Alliance Garments Ltd.

20 May 2014

Structural Inspection Report

Observations & Actions

Checked Ground Floor Column – Brick Chips

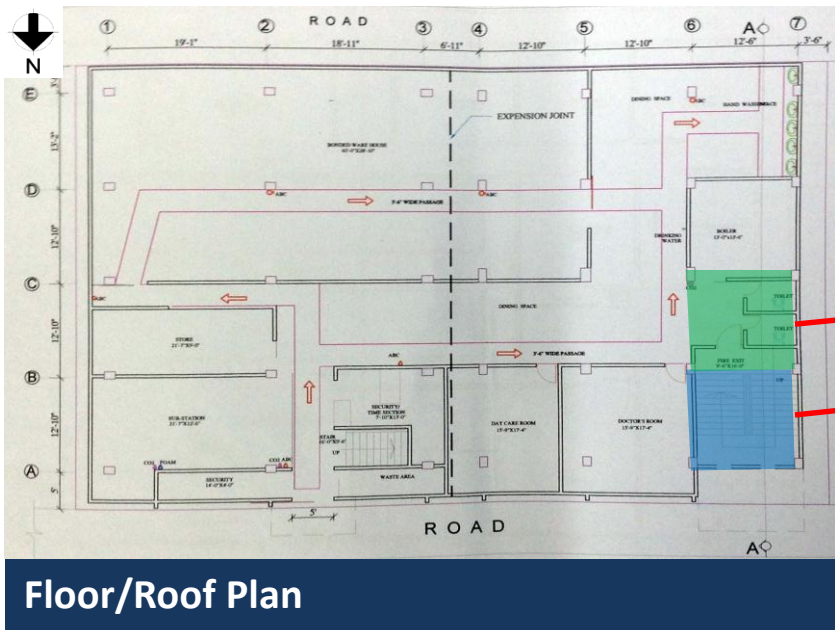
Columns, within the eastern section of the factory, appear to be stressed in excess of normal design limits

Design check to be carried out on all concrete columns in the highlighted area

Outline calculations indicate that column working stress, within the area highlighted on the above floor plan, is in excess of normal design limits

Building Engineer is to perform detailed calculations and concrete tests to prove column size and (if required):

- Reduce loads by vacating floors
- Reinforce columns

Existing reinforcement in columns to be verified on site by Building Engineer

Cracking on the walls below the water tanks

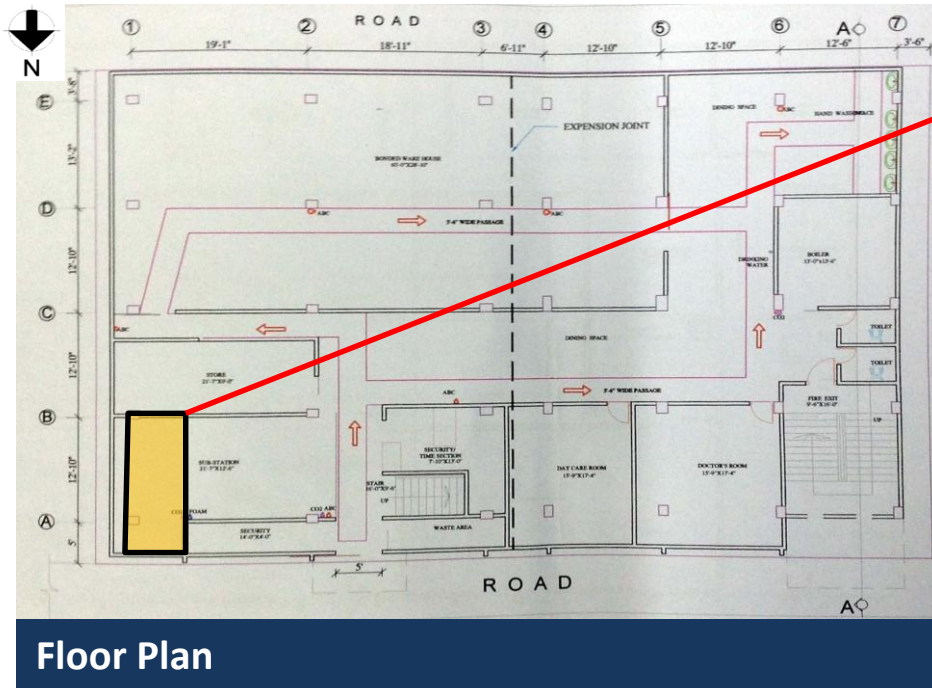
Design check on structure supporting roof top water tanks

Building Engineer to review structural support to concrete and plastic water tanks and confirm the adequacy of this support.

Management of Floor Loads

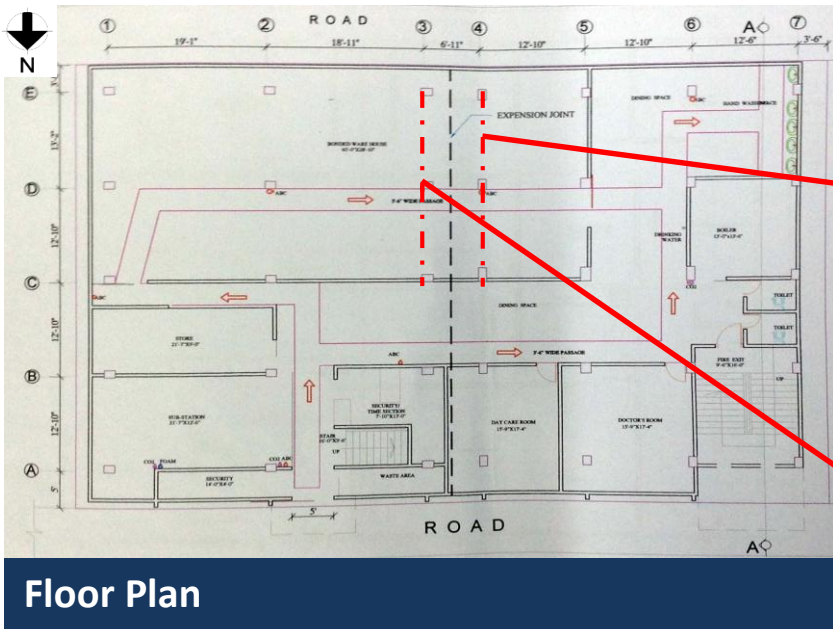
Management of floor loads and design check on capacity of floor slab to support floor build-up loads in toilet areas

5th Floor Storage

Toilet Floor Build up

Building Engineer to prepare controlled loading plans, based on floor slab and column capacity, for all floors which will designate allowable storage density and where storage may be placed.

Cracking on Soffit of Roof Beams

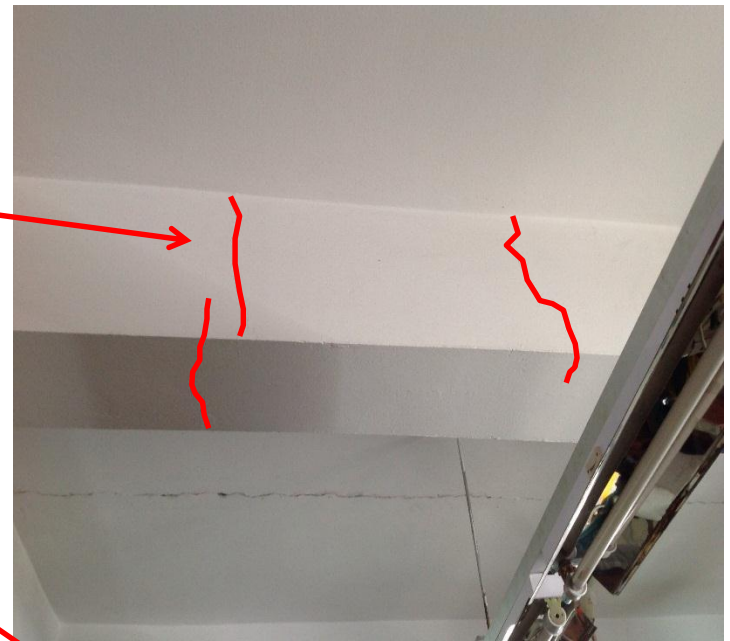
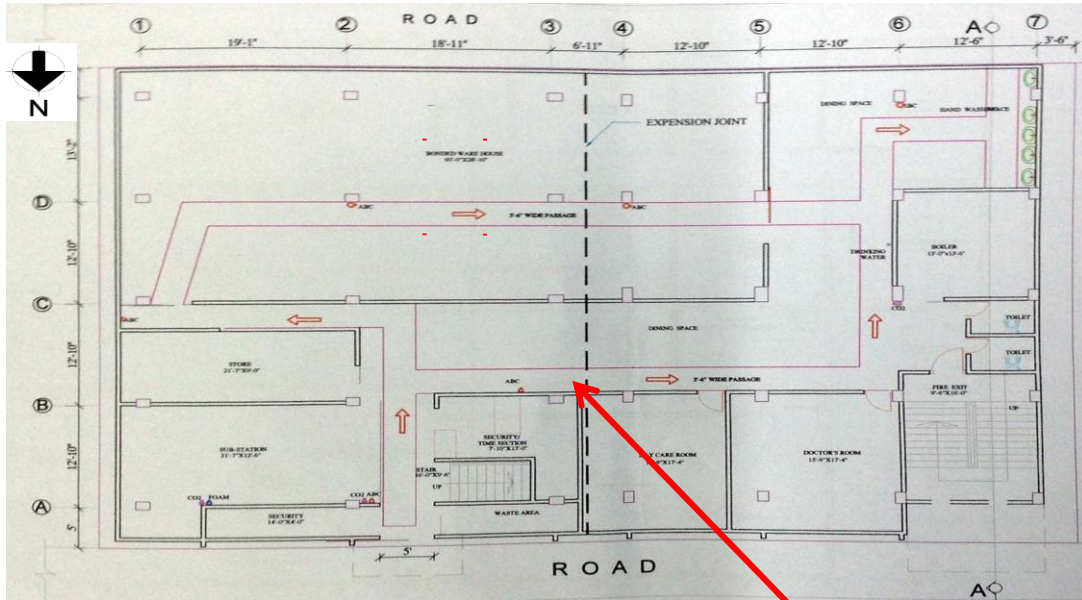
Cracking to beams at underside of roof

Cracking of beams on the soffit of the roof to be reviewed, by removing plaster, to confirm that cracks do not extend into the structure.

Item 1 and actions

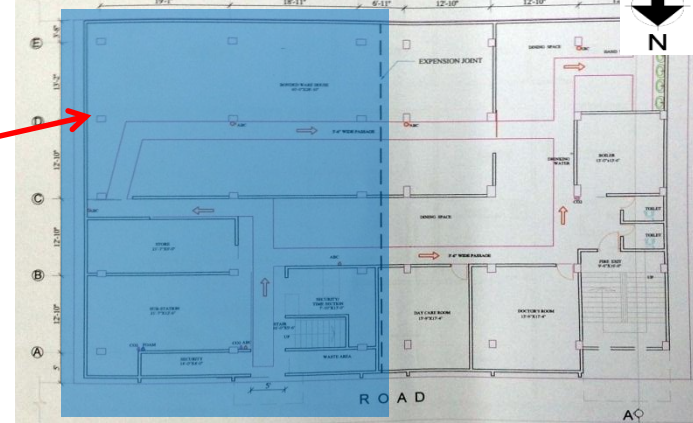
Columns, within the eastern section of the factory, appear to be stressed in excess of normal design limits

- Factory Engineer to review design, loads and column stresses in area identified above.
- Verify insitu concrete strengths (using min. 4 no. 100mm dia. Cores) and existing reinforcement for all columns.
- Produce and actively manage a loading plan for all floor plates within the factory giving consideration to floor capacity and column capacity.
- Update existing floor loading plans to distinguish between allowable and actual imposed floor loads

- Continue to implement load management plan
